**CAMECO RESOURCES
CROW BUTTE OPERATION**

Annual Report of Changes, Tests, or Experiments
License No. SUA-1534
Docket No. 40-8943

Crow Butte Resources, Inc. (CBR) d/b/a Cameco Resources – Crow Butte Operation (CBO) is providing this annual report summarizing the changes, tests or experiments made under License Condition 9.4 of SUA-1534 during calendar year 2016. This report is made in accordance with the reporting requirements contained in License Condition 9.4 (E).

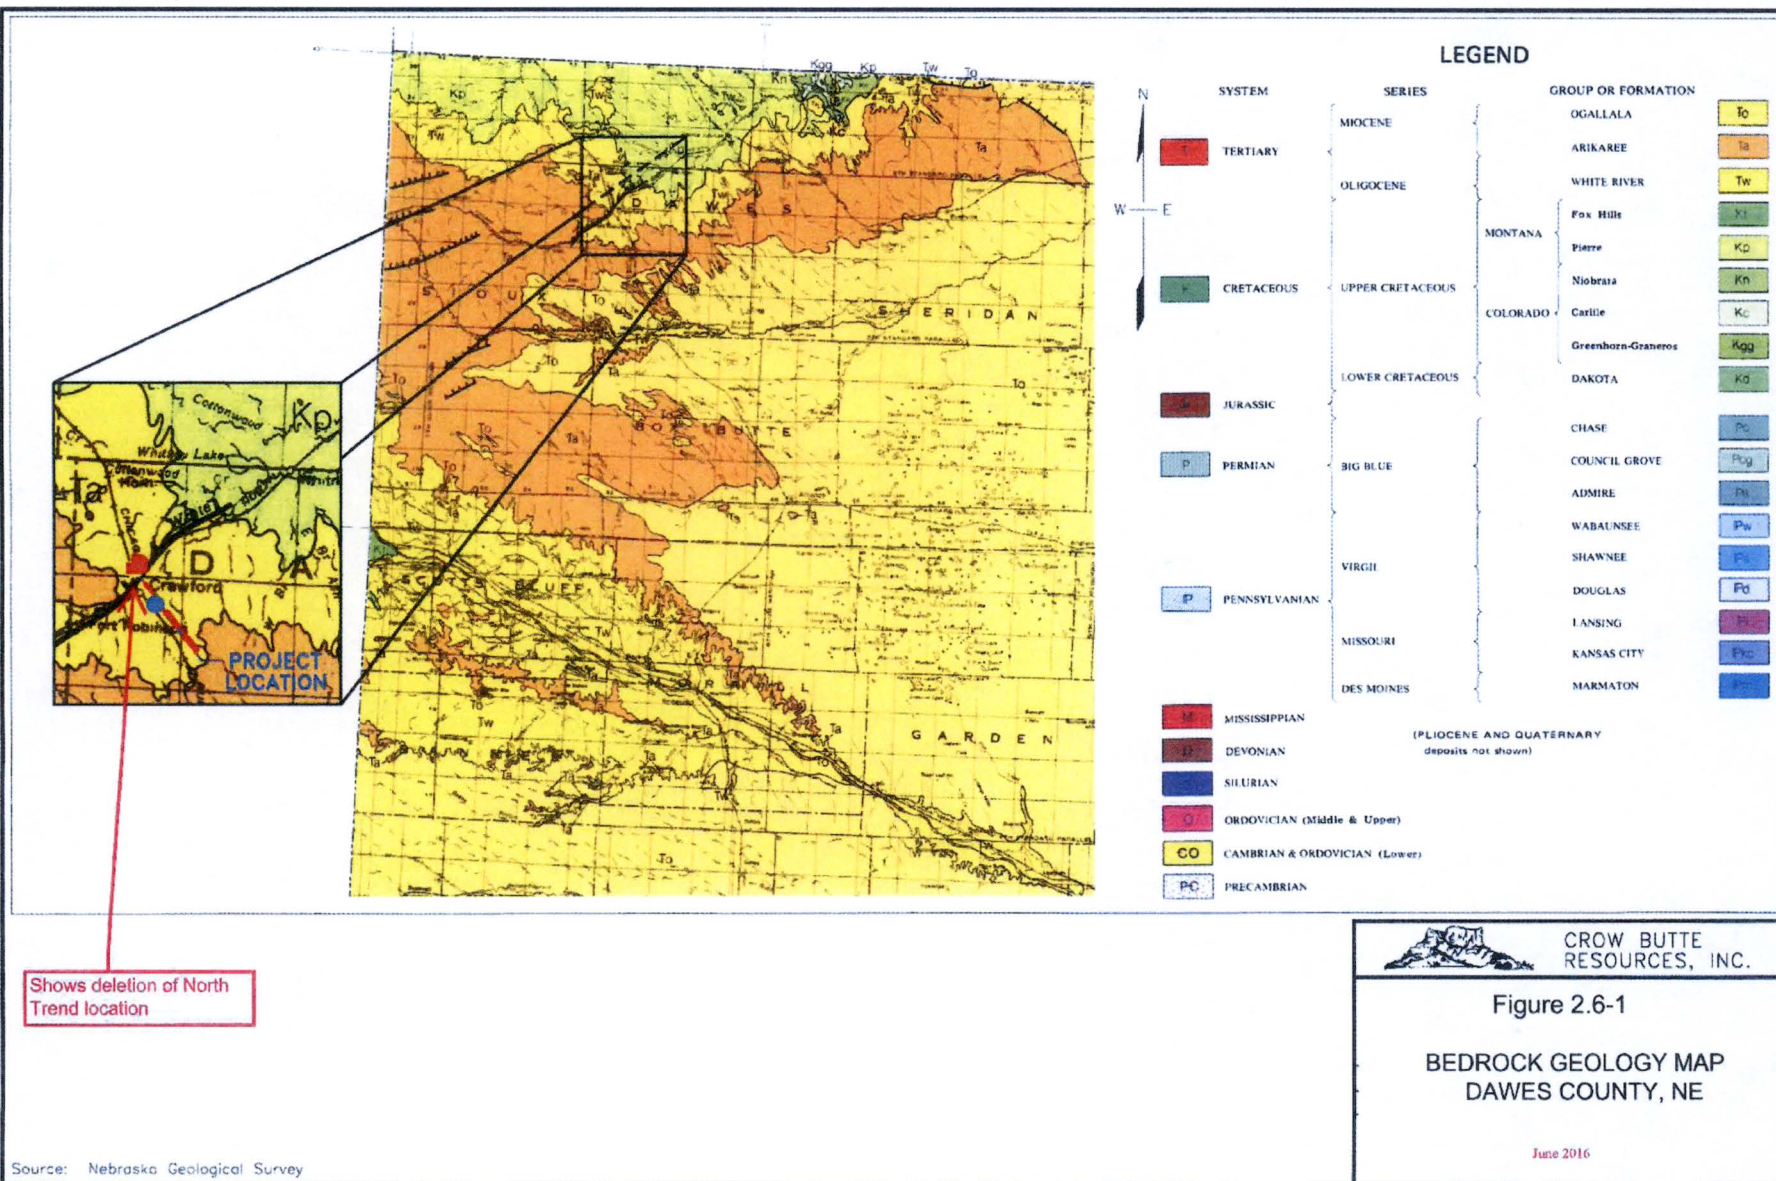
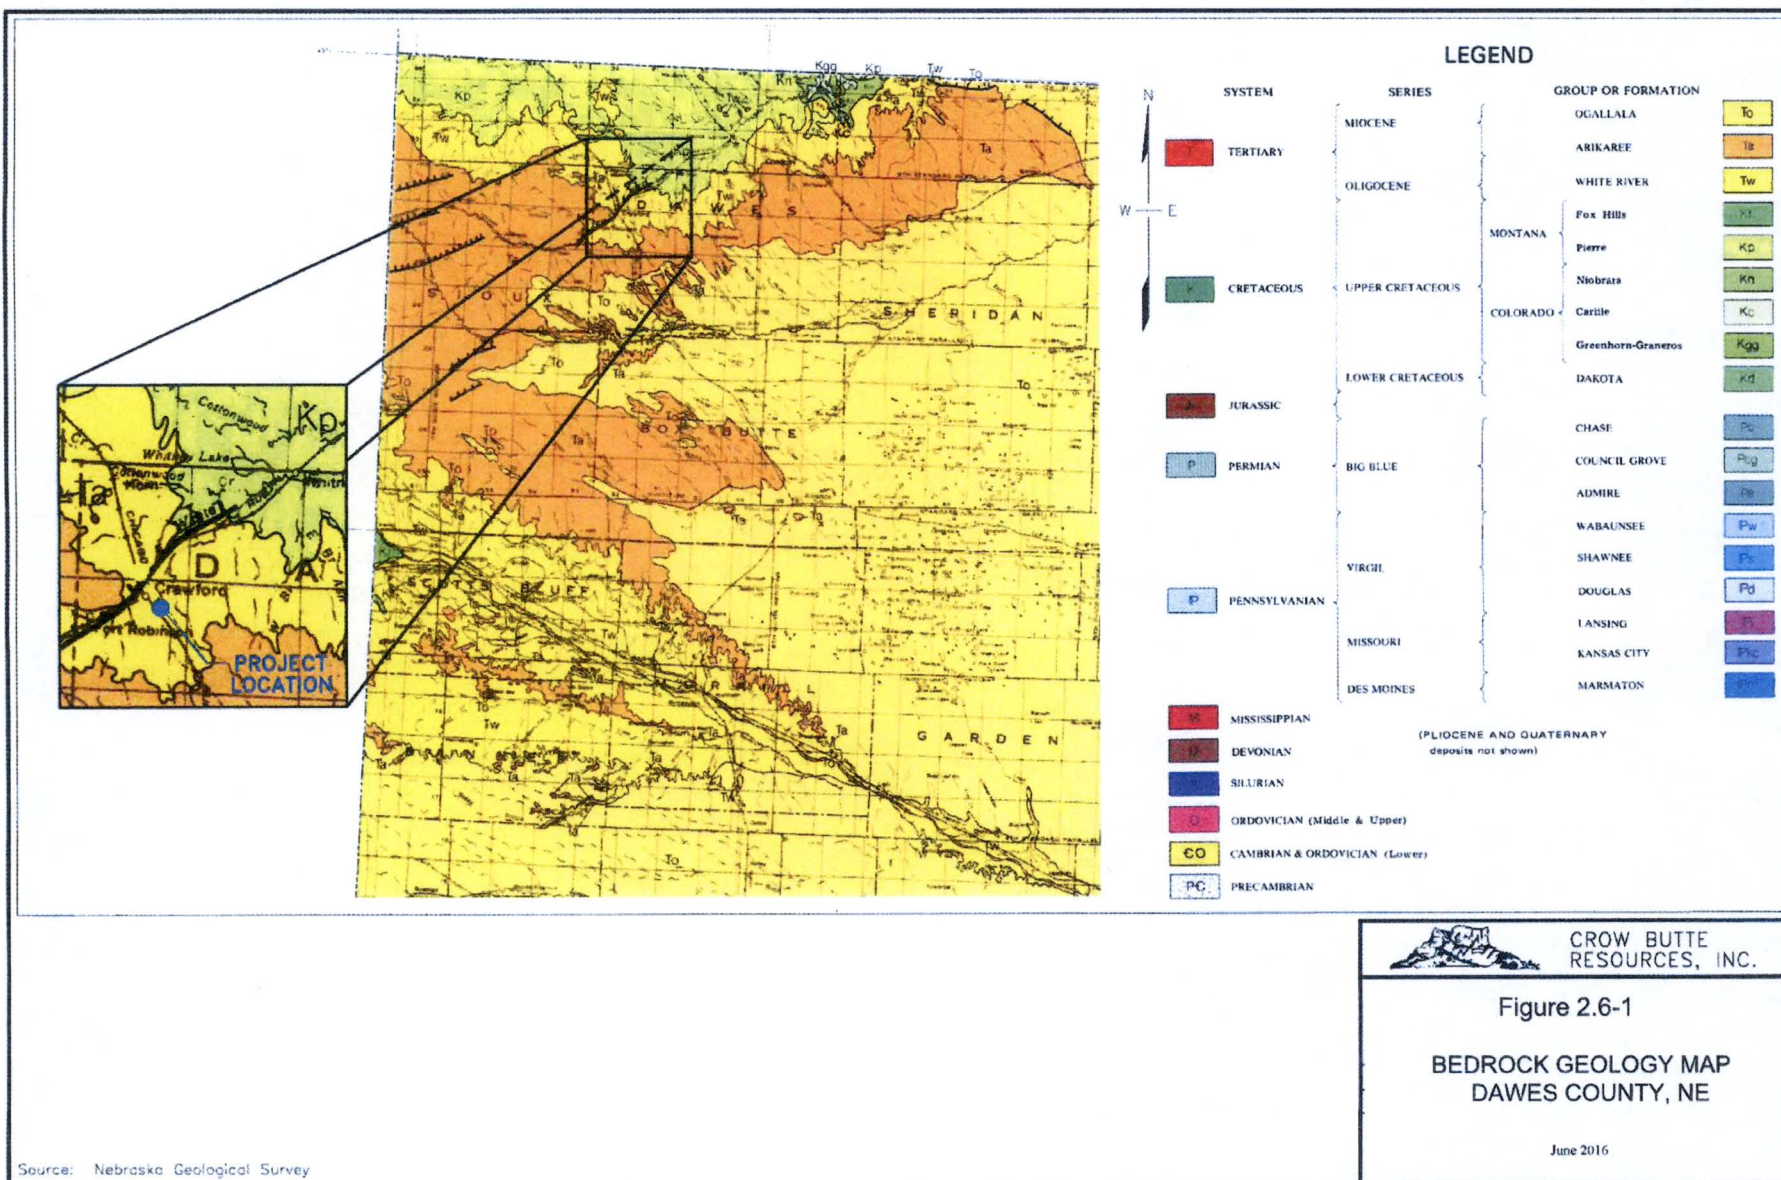
Section 2.6.1, Regional Setting - Revised Figure 2.6-1 to show the location of the license area. The revision to this figure does not change the intent of Section 2.6 of the SER.

**FIGURE 3.1-7
PROCESS FLOW SHEET
FOR CENTRAL PLANT AND/OR
SATELLITE FACILITY**

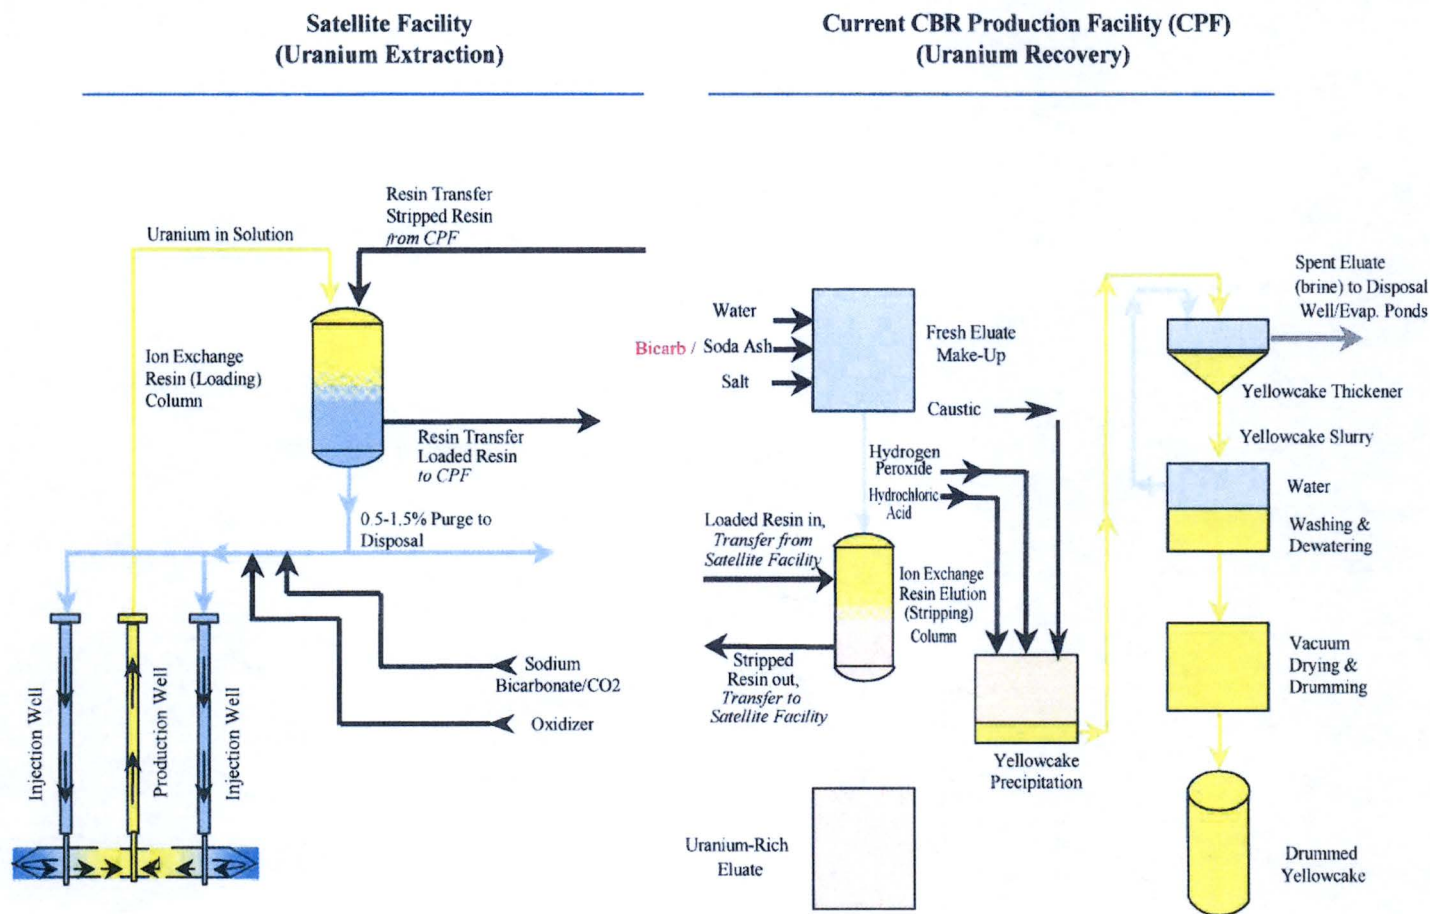
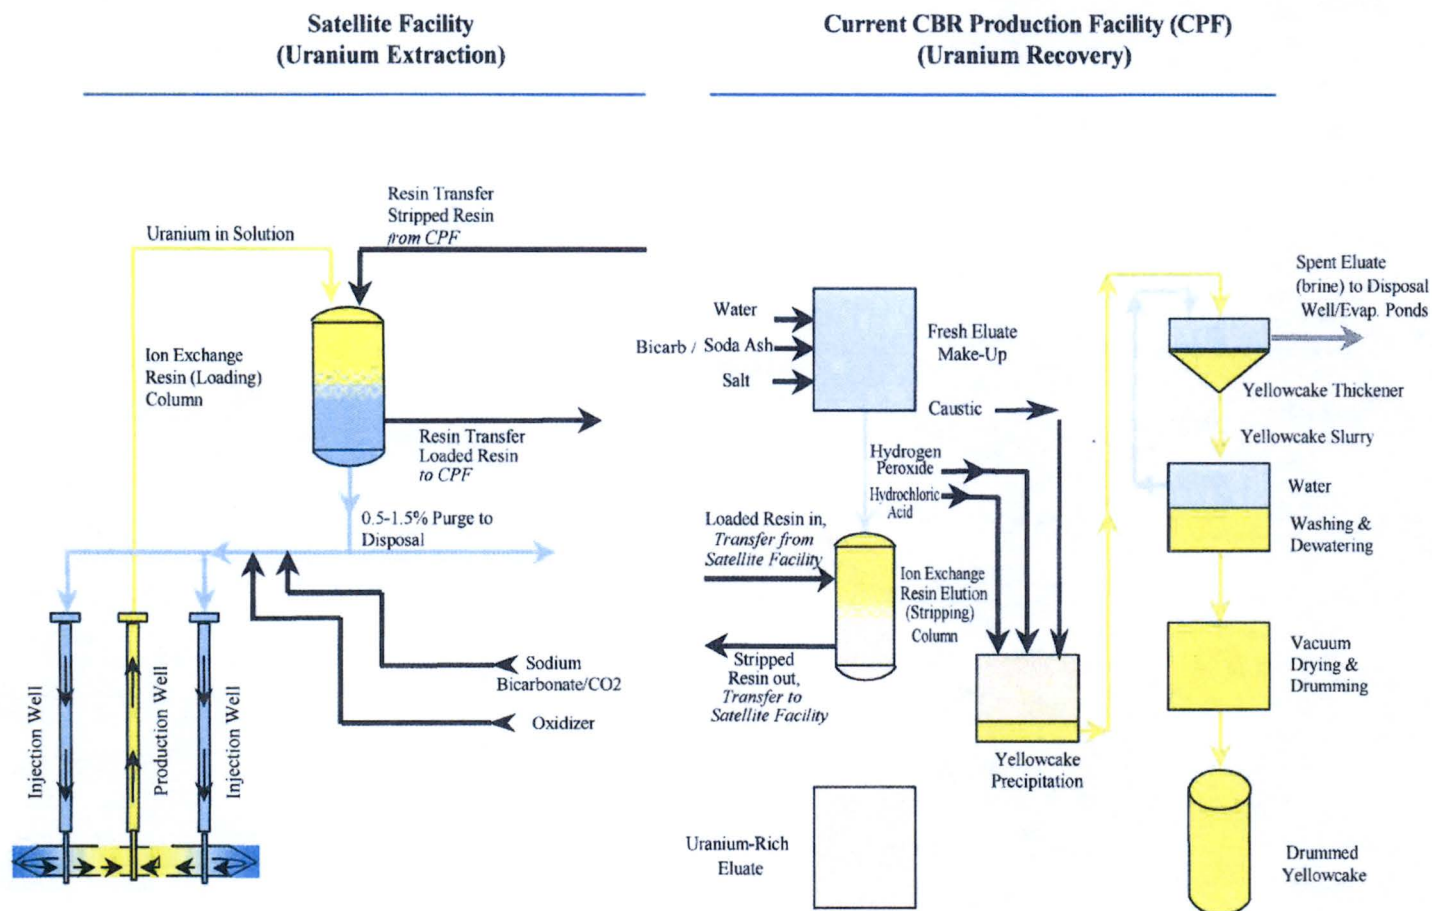
Section 3.1.4, Process Description - Revised Figure 3.1-7 to add the other carbonate species that is used (bicarb) in the process. The use of bicarbonate is described in the NRC staff's review in Section 3.2.3 of the SER. The revision to this figure does not change the intent of the NRC staff's review.
